ADDENDUM NO. CC-1

August 1, 2014

Northeast Community College
NECC Extended Campus – O’Neill, NE
505 East Highway 20
O’Neill, NE 68763
BCDM Project No. 3529-02

3529	DRAWING REFERENCED: 1/A1-1	ATTACHMENT
8/4/2014 9:56:10 AM	ADDENDUM NO. CC-1	ASD-03

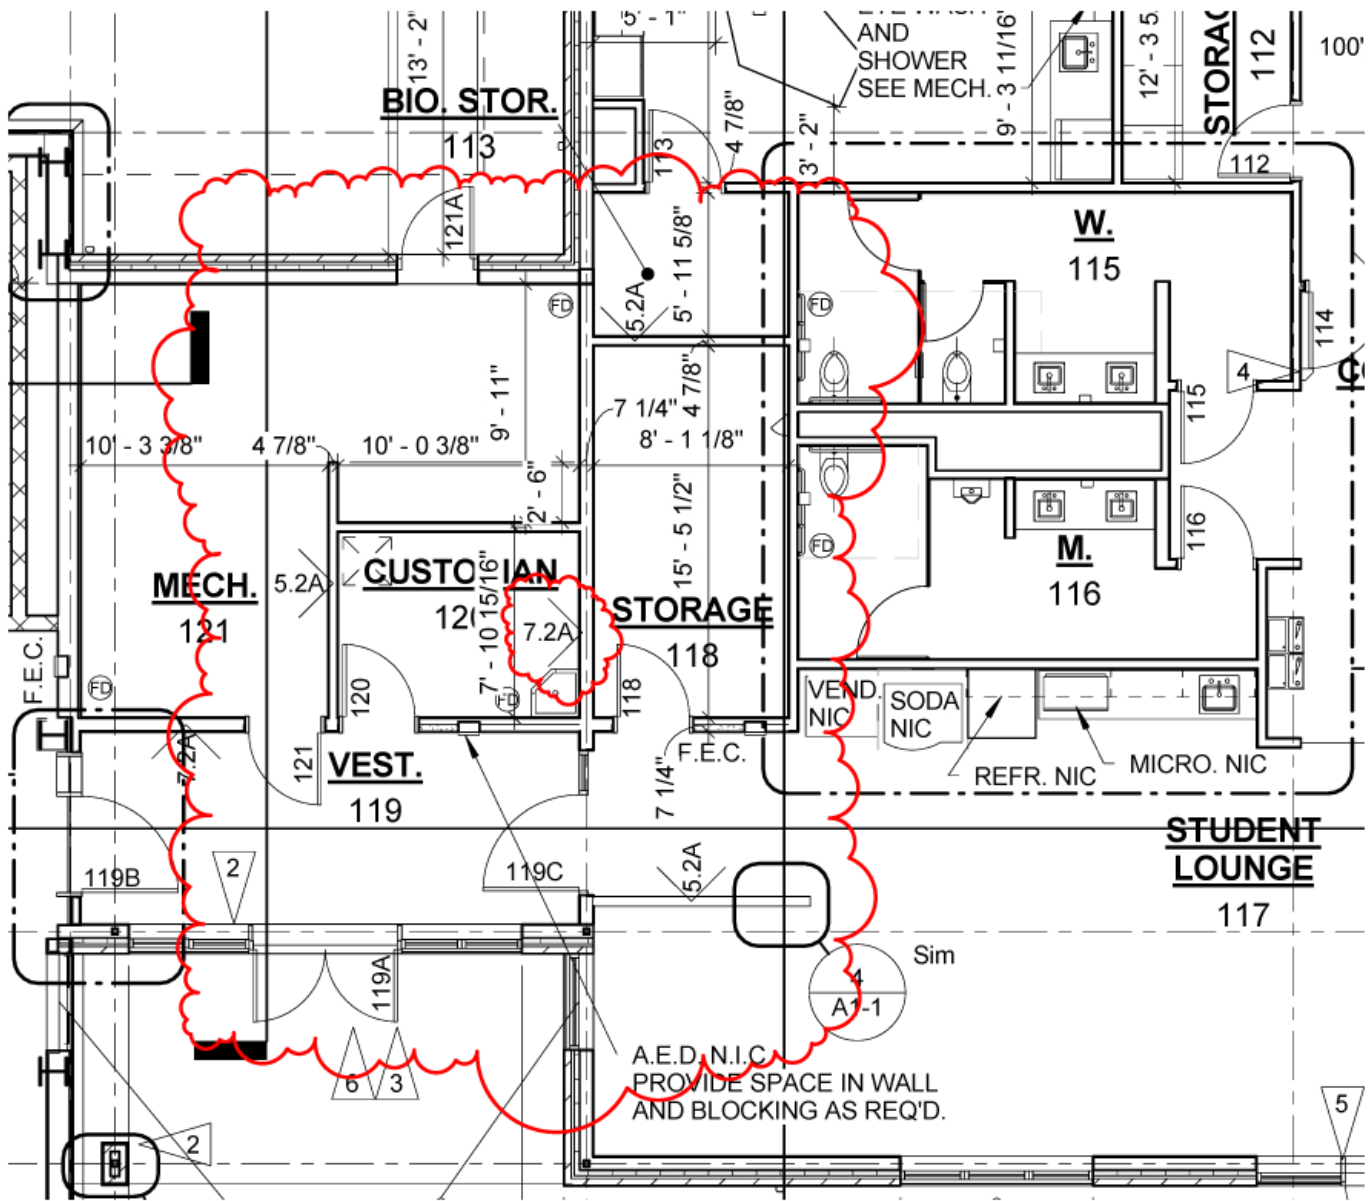
- a. For details 5, 6, 7, and 8 of this sheet, replace the note "PROVIDE TRASH ENCLOSURE UNDER ALTERNATE #04 ONLY" with "PROVIDE TRASH ENCLOSURE UNDER ALTERNATE #03 ONLY"
- b. At south pair of doors into STOR. 134, change number of door mark to 134B in lieu of 138B.
- c. Reference ASD-03 for north-south running wall change from 5.2A to 7.2A wall type. See attached drawing for clarification.

3529	DRAWING REFERENCED: 1/A1-2	ATTACHMENT
8/4/2014 3:30:50 PM		ASD-05

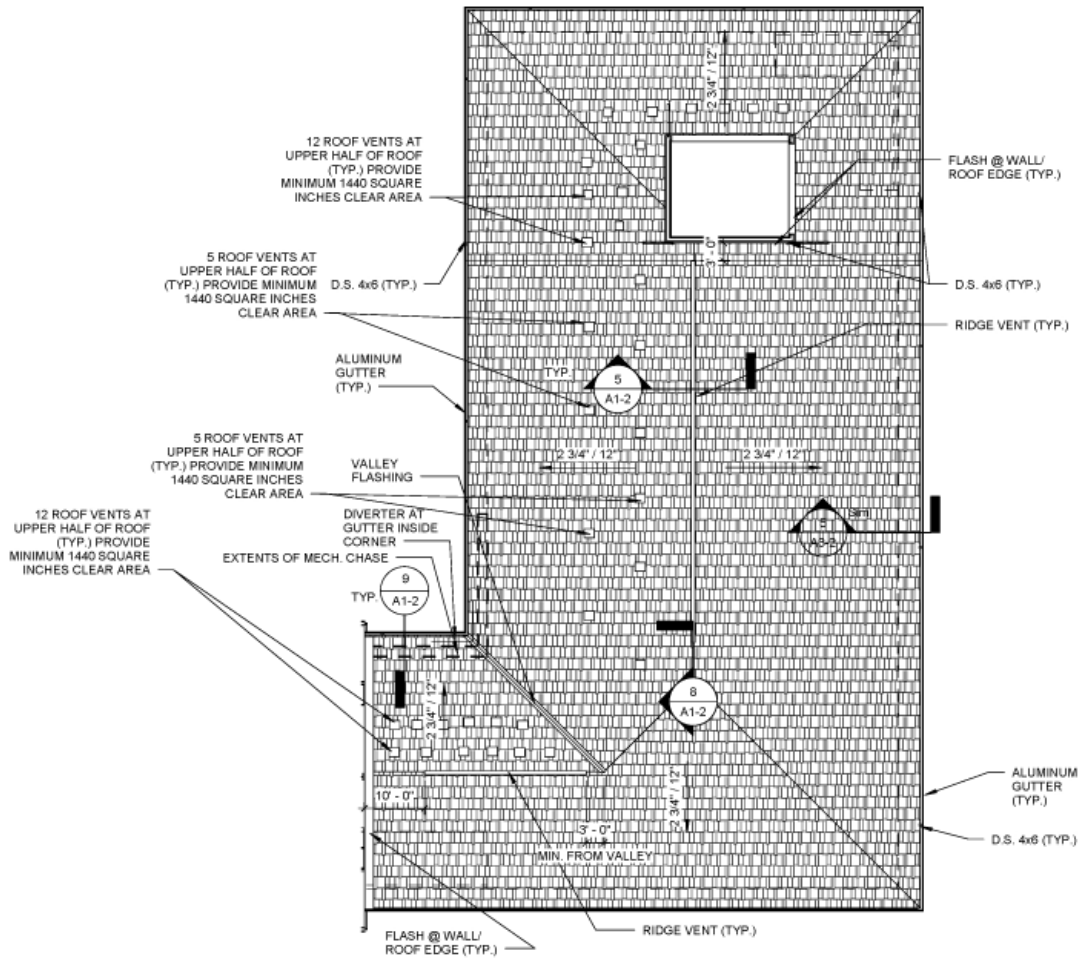
- a. For drawing 1/A1-2, replace with the attached drawing ASD-05 revising roof vent locations.

② CEILING TRANSITION AT RECEPT./LOBBY 102.
3/4" = 1'-0"

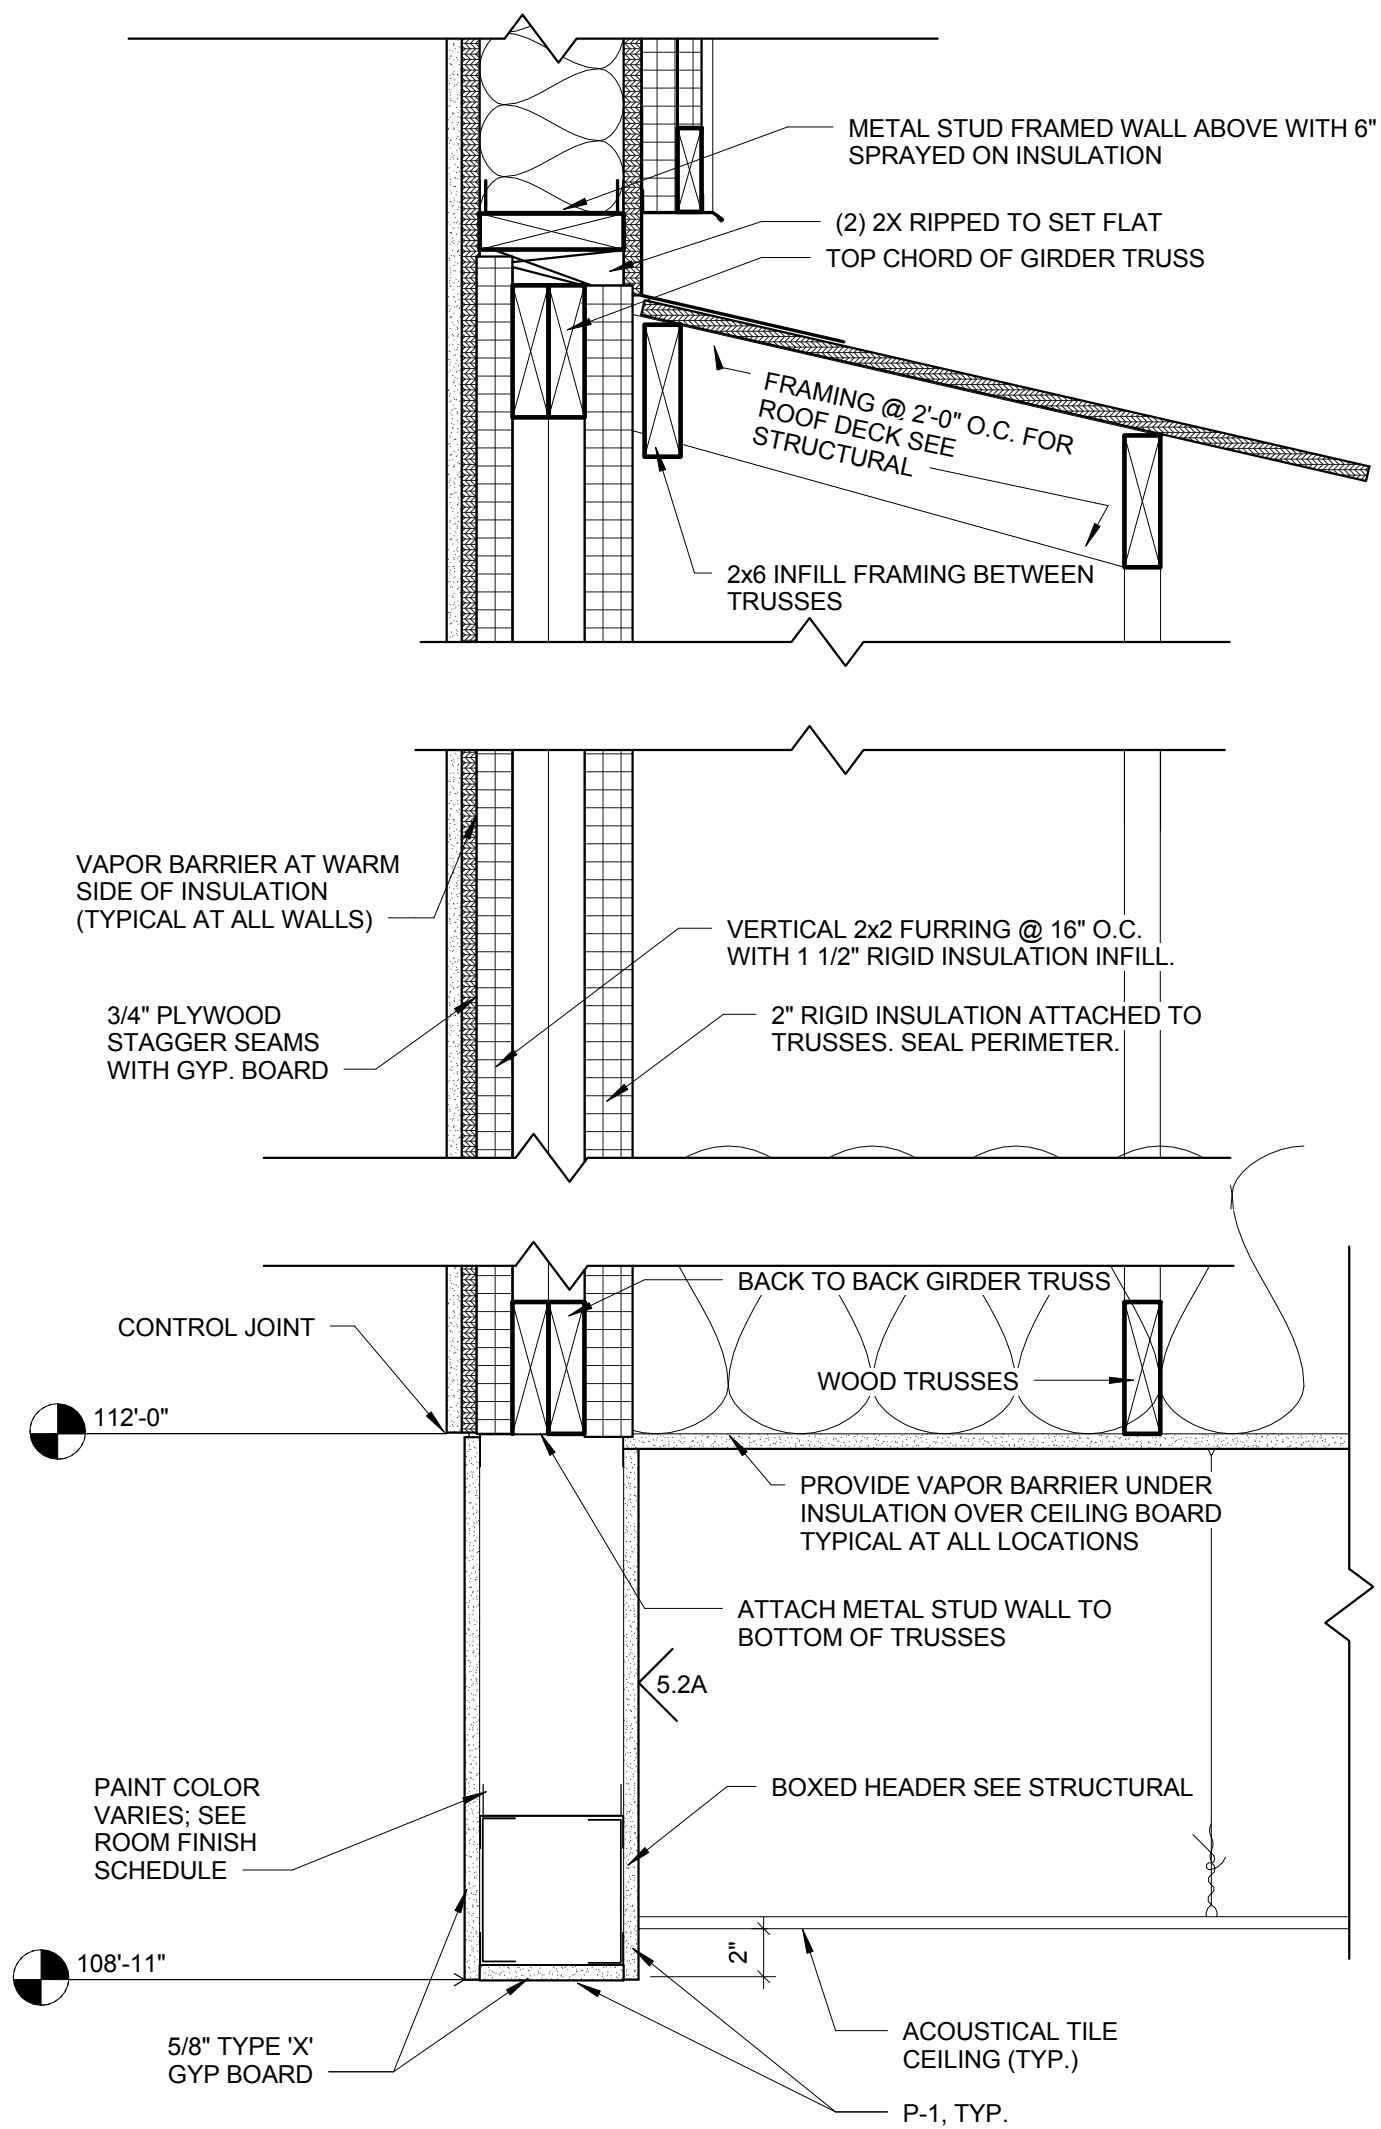
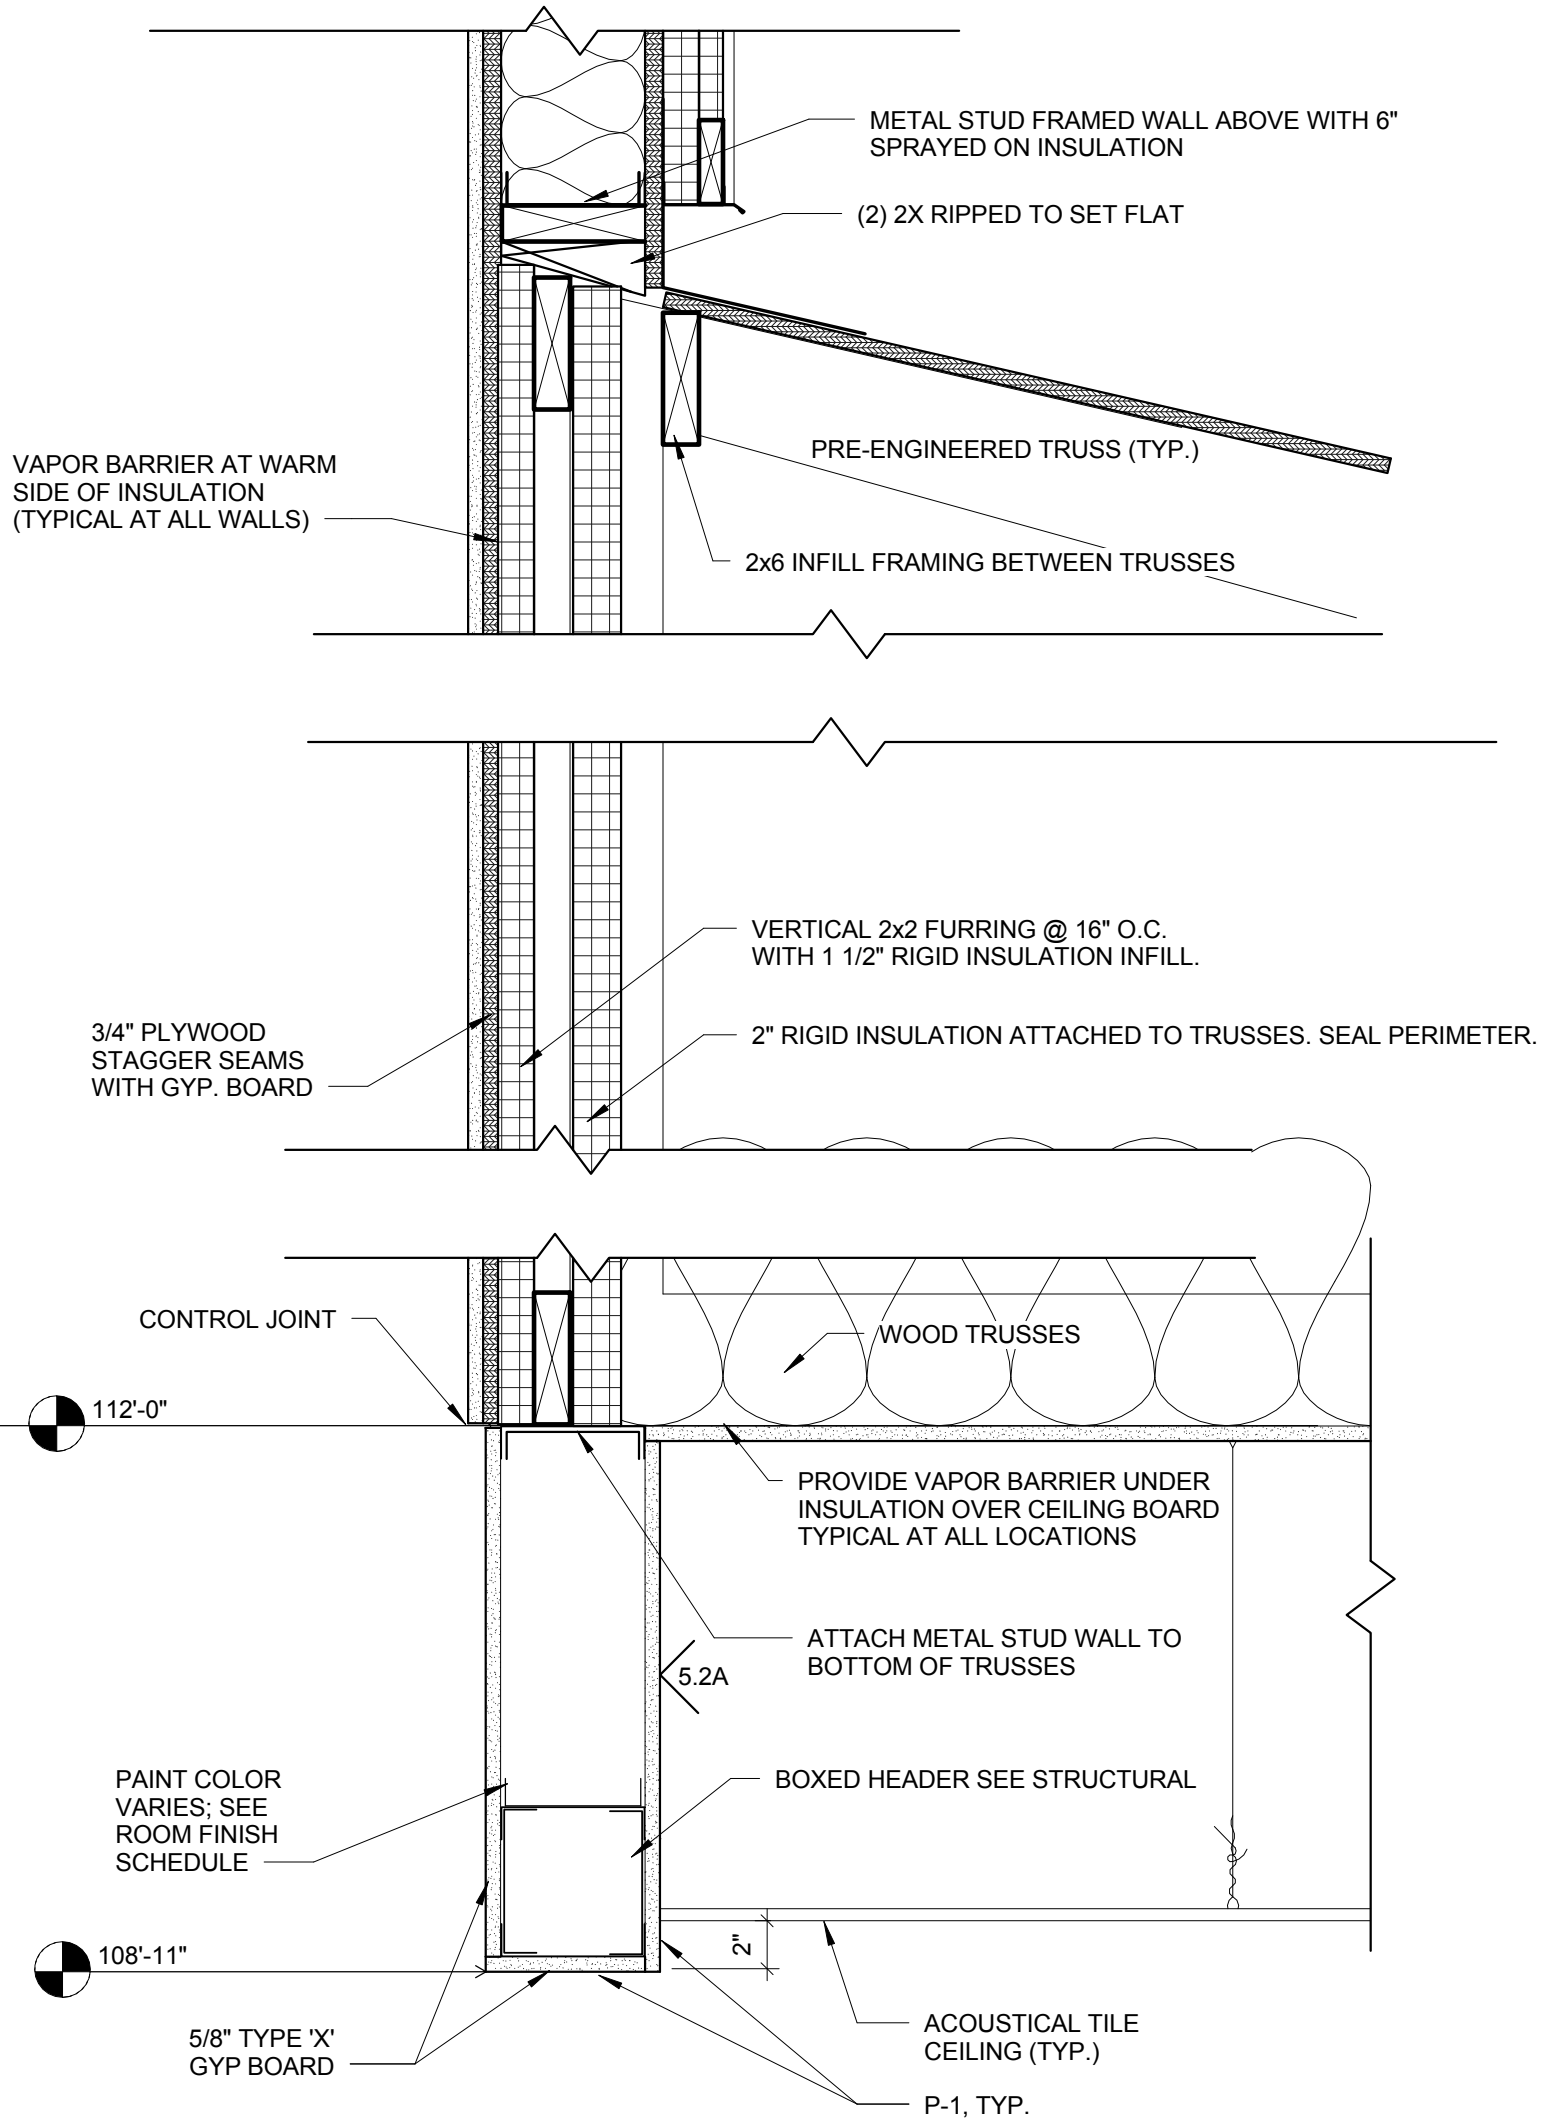
- a. Reference ASD-01 and ASD-02 for changes to details 2/A5-1 and 6/A5-1.
- b. Add note to drawing 3/A5-1. "COMPLETELY ENCASE RAISED AREA FOR FOLDING PARTITION STEEL WITH BLOWN IN INSULATION OR AT CONTRACTOR'S OPTION, PROVIDE BLANKET BATT INSULATION TO MATCH R-VALUE REQUIREMENT AT THIS LOCATION.

3529	DRAWING REFERENCED: 1/A1-2	ATTACHMENT
8/4/2014 3:30:50 PM		ASD-04

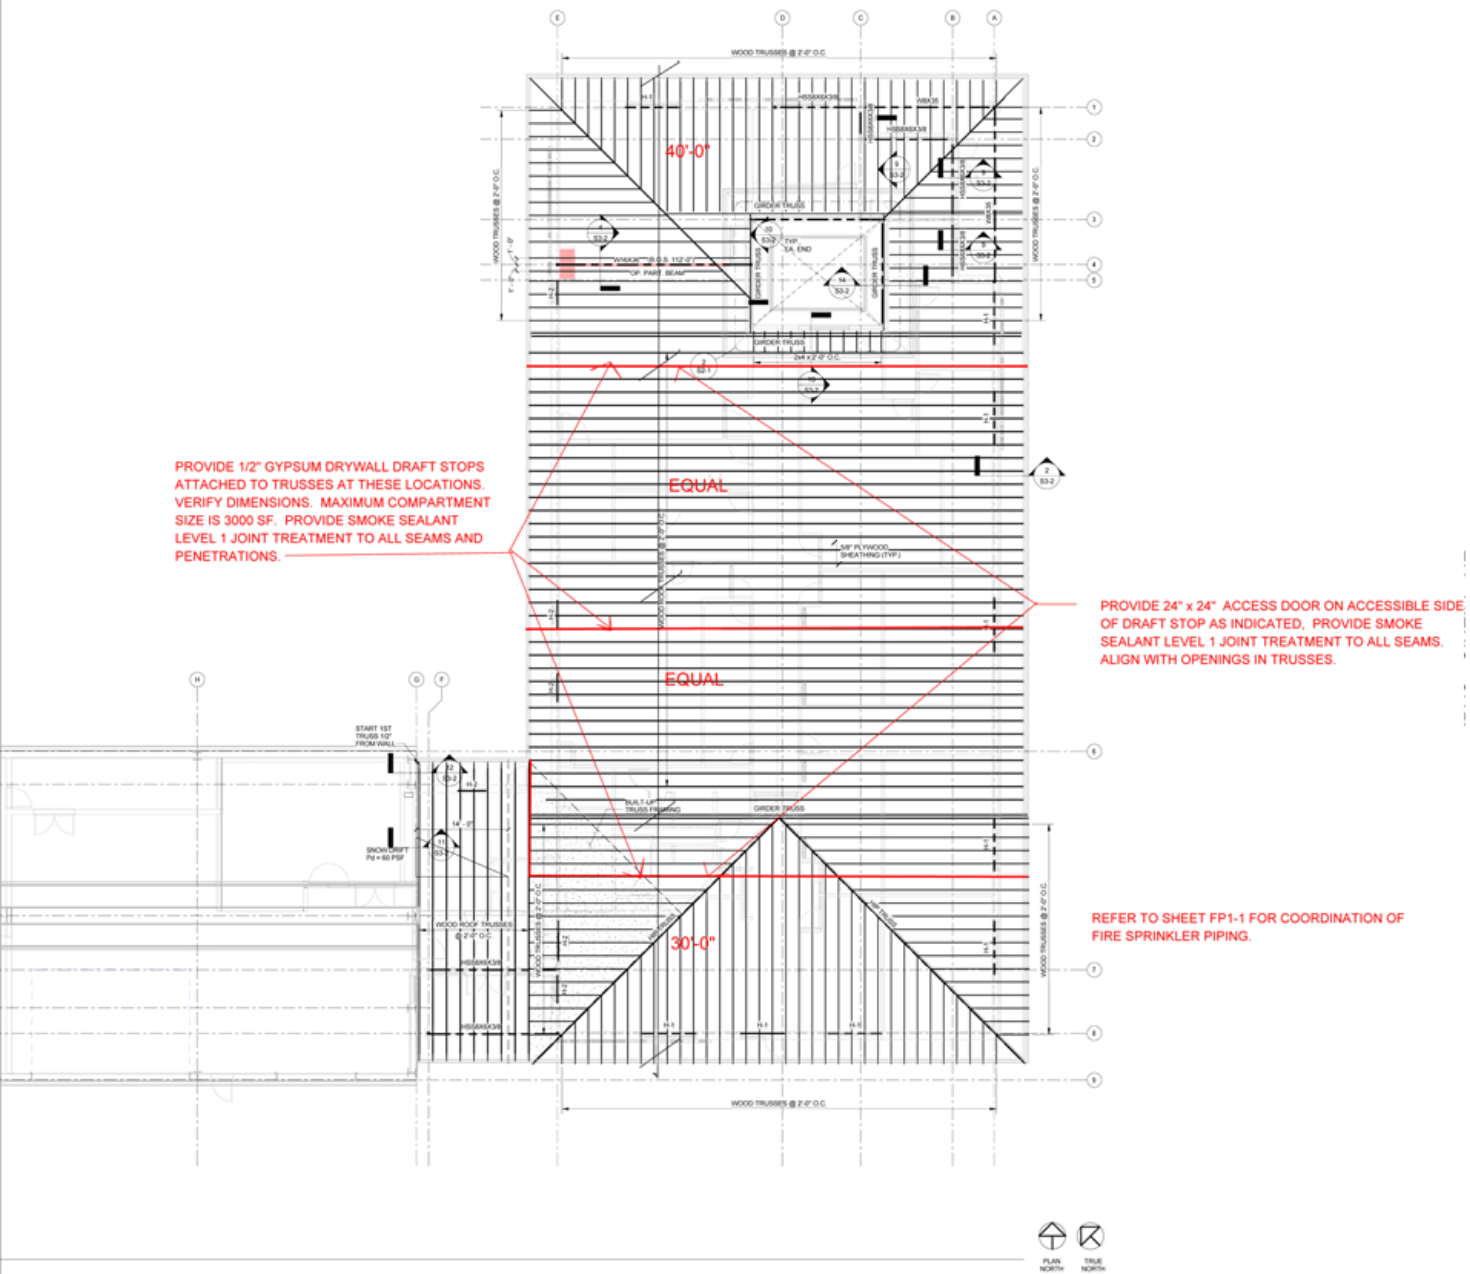
- a. See attached drawing ASD-04 describing draft stops in the attic and access doors within this space.

PROVIDE 1/2" GYPSUM DRYWALL DRAFT STOPS ATTACHED TO TRUSSES AT THESE LOCATIONS. VERIFY DIMENSIONS. MAXIMUM COMPARTMENT SIZE IS 3000 SF. PROVIDE SMOKE SEALANT LEVEL 1 JOINT TREATMENT TO ALL SEAMS AND PENETRATIONS.

PROVIDE 24" x 24" ACCESS DOOR ON ACCESSIBLE SIDE OF DRAFT STOP AS INDICATED, PROVIDE SMOKE SEALANT LEVEL 1 JOINT TREATMENT TO ALL SEAMS. ALIGN WITH OPENINGS IN TRUSSES.

REFER TO SHEET FP-1 FOR COORDINATION OF FIRE SPRINKLER PIPING.
